Subject: CPV Sentinel, LLC Energy Project (07-AFC-3)

Mission Creek Ground Water Subbasin

David K. Luker, General Manager of Desert Water Agency, has requested Krieger & Stewart to comment on the estimated time it takes water infiltrated at the Mission Creek Recharge Basins to reach the underlying ground water table and the estimated transmissivity of the Mission Creek Ground Water Subbasin aquifer, particularly within the vicinity of the aforementioned recharge basins and CPV Sentinel, LLC's Energy Project.

KRIEGER		DESERT W	ATER AGENCY		FIGURE
STEWART INCORPORATED	MISSION CREEK SUBBASIN CPV SENTINEL ENERGY PROJECT				1
3602 University Ave. • Riverside, CA. 92501 • 951-684-6900	WATER RECH		AND WATER WELL		1
SCALE: N.T.S.	DATE: 10/6/08	DRAWN BY: TMW	CHECKED BY: DFS	W.O.:101-73	OF 3

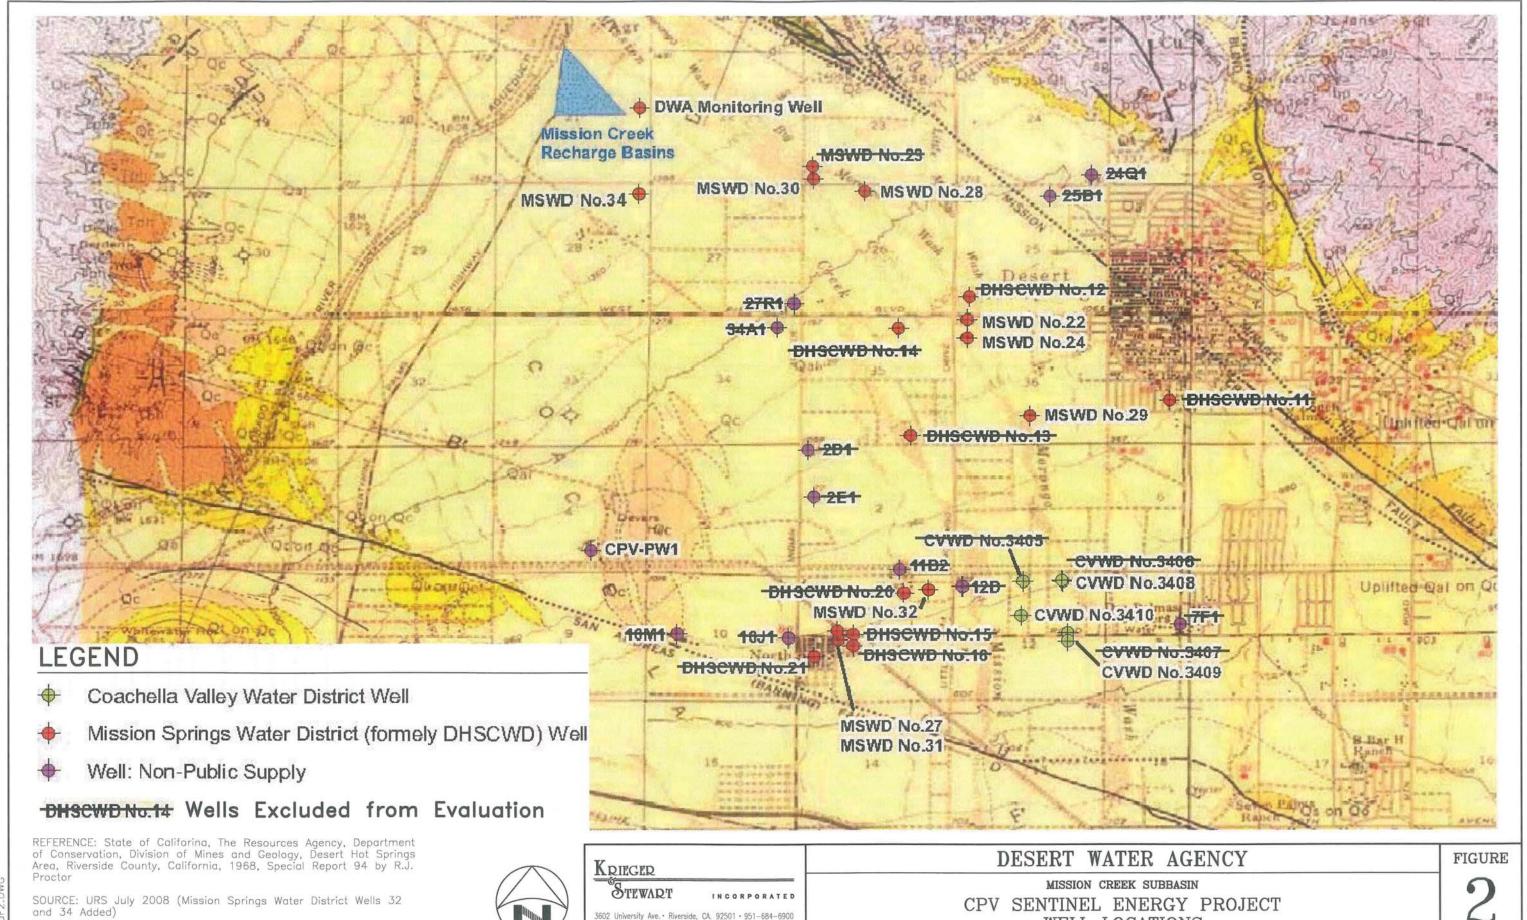
Figure 1, attached, shows water levels in the Mission Creek Monitoring Well (MCMW) located at the Mission Creek Recharge Basins and in Mission Springs Water District's (MSWD) Well 30, both as related to ground water recharge. Water levels are expressed in measured depth to the water table and recharge is based on Metropolitan Water District month-end water delivery meter readings.

The first indication of rising water level in the MCMW was on May 29, 2003 (about seven months after initiation of recharge activities), when the water level rose 1.5 feet (ft) from the previous measurement, which was made on April 18, 2003 (about six months after initiation of recharge activities).

Based on the above (taking into account the frequency of MWD meter readings, MCMW water level measurements, and excluding the initial recharge event due to insufficient water level measurement data), we conclude that the time required for water discharged into the Mission Creek Recharge Basins to reach the underlying aquifer ranges between two and four months, depending upon the extent of time between recharge events, based on 2004 and 2006 recharge events.

TRANSMISSIVITY VALUES

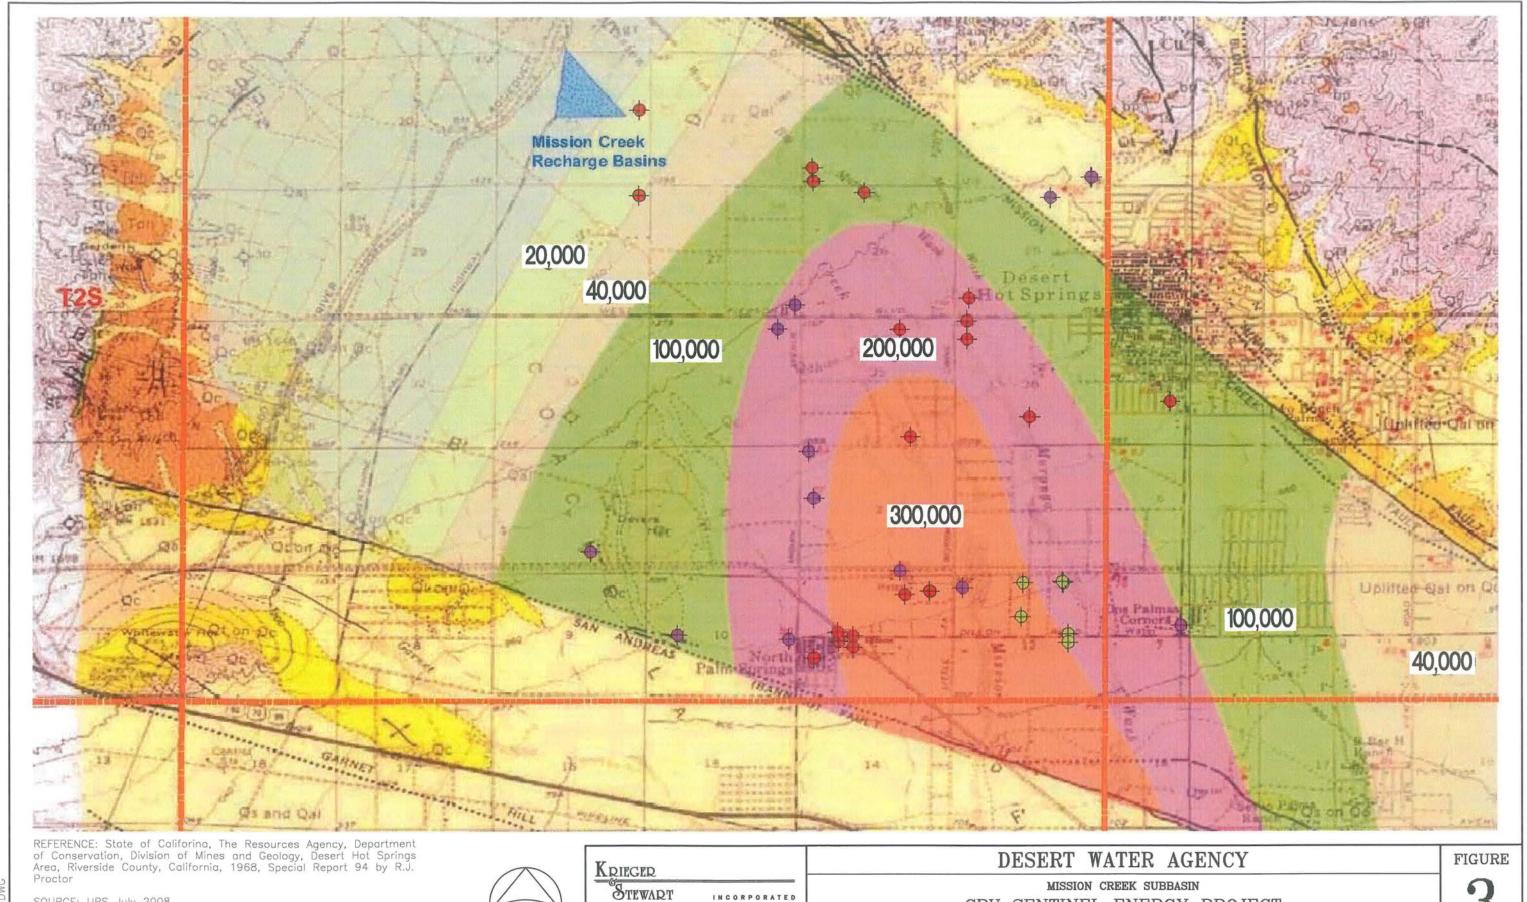
Our estimated transmissivity ranges are shown on Figure 3, using Tyley's original transmissivity distribution patterns to show approximate regions with similar transmissivities. As shown thereon, MSWD Wells 27, 31, and 32 and CVWD Well 3410 fall within the 300,000 transmissivity zone (with CVWD Well 3410 close to the boundary with the 200,000 zone); MSWD Wells 22, 24, and 29 and CVWD Wells 3408 and 3409 fall within the 200,000 transmissivity zone (with CVWD Well 3409 close to the boundary with the 300,000 zone); MSWD Wells 28 and 30 and the CPV PW-1 Well fall within the 100,000 transmissivity zone; and MSWD Well 34 falls on the boundary between the 20,000 and 40,000 transmissivity zones. MSWD Well 34 is currently not in operation. Although MSWD Well 34 operated initially with a specific capacity of approximately 26 gpm/ft dd, corresponding to a transmissivity of about 47,000 gpd/ft, the specific capacity declined precipitously over time to less than 5 gpm/ft dd, at

which point the pump, damaged by cavitation, was removed from service. Based on the calculated transmissivities at the above-noted well locations, some adjustments to the original Tyley transmissivity distribution are warranted. Regardless, based on data available subsequent to Tyley's investigation, Tyley's transmissivity figures can safely be increased by a factor of 1.5 to 2.

In summary, water infiltrated at the Mission Creek Recharge Basins will reach the underlying ground water table in two to four months based on two specific recharge events (2004 and 2006), and estimated transmissivity within the Mission Creek Ground Water Subbasin Aquifer is 1.5 to 2 times Tyley's estimates based on data which became available subsequent to Tyley's investigation. We have increased Tyley's transmissivity estimates from 200,000 gpd/ft to 300,000 gpd/ft, from 100,000 gpd/ft to 200,000 gpd/ft, from 50,000 gpd/ft to 100,000 gpd/ft, from 25,000 gpd/ft to 40,000 gpd/ft, and from 10,000 gpd/ft to 20,000 gpd/ft based on such data.
